P&Z Remarks on 29-4.8_11/16/16

Columbia Development Code Public Hearing Draft

29-4.8 Neighborhood Protection Standards

Re: Columbia UDC – Columbia Development Code Public Hearing Draft Requested changes to Section 29 – 4.8 (e)

Illustrations of structures that meet 35' eave measurement (Section 29-4.8(h) of UDC)

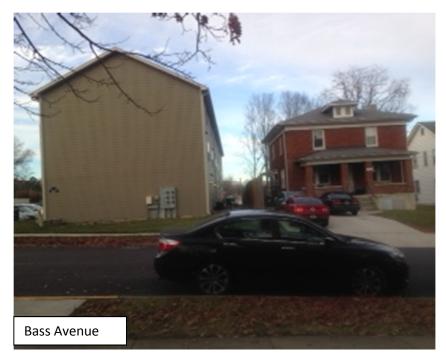
Neighborhood Protection Photos, Janet Hammen

Accompanies J. Hammen's proposed changes submitted 12/8/16 to same section of UDC
